Bulletin # SB-5K-001

SERVICE BULLETIN

Ride Name: Cliff Hanger

Abstract of Issue: Dartron is aware of Cliff Hanger rides that have developed cracks in the bearing base. The cracks may result from or be aggravated by transporting the Cliff Hanger without adequately supporting the sweeps and/or from unbalanced ride loading.

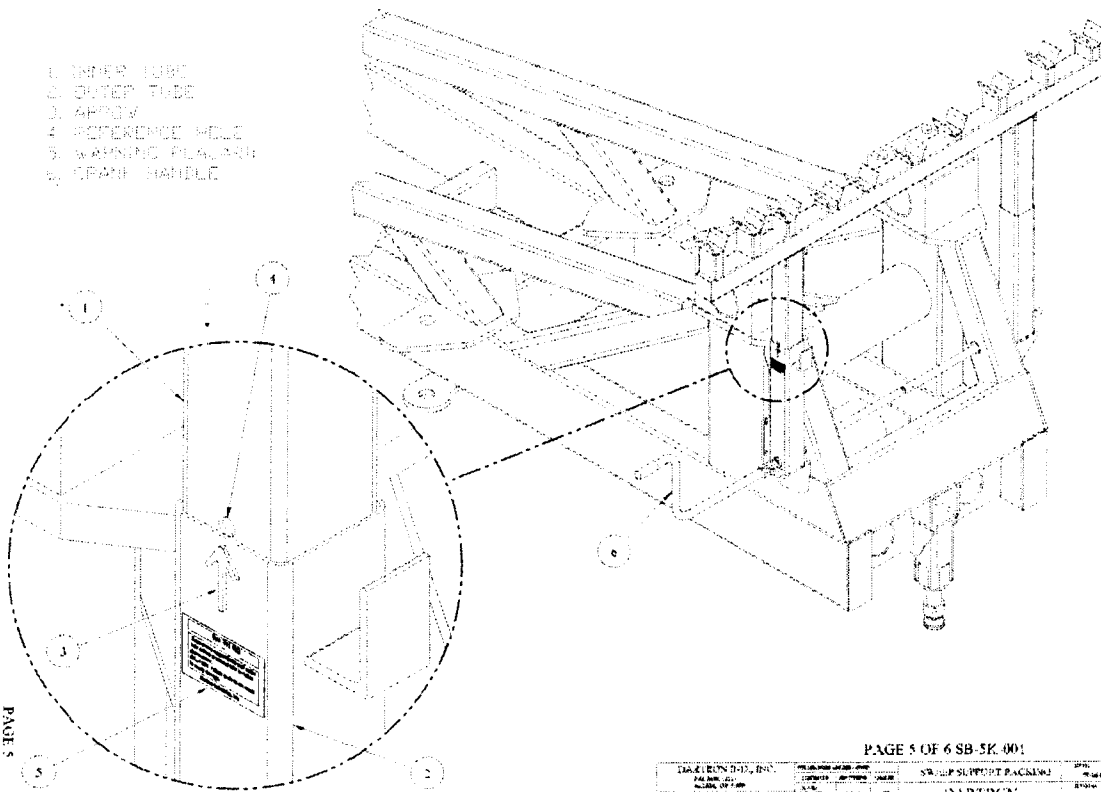
Step 3: Three areas must be visually inspected. Those areas are shown on Page 3 as Detail A, B and C.

Step 5: Visually inspect the three areas for cracks or broken paint.

Step 6: If broken paint is found, the paint must be removed to allow a more through visual crack inspection.
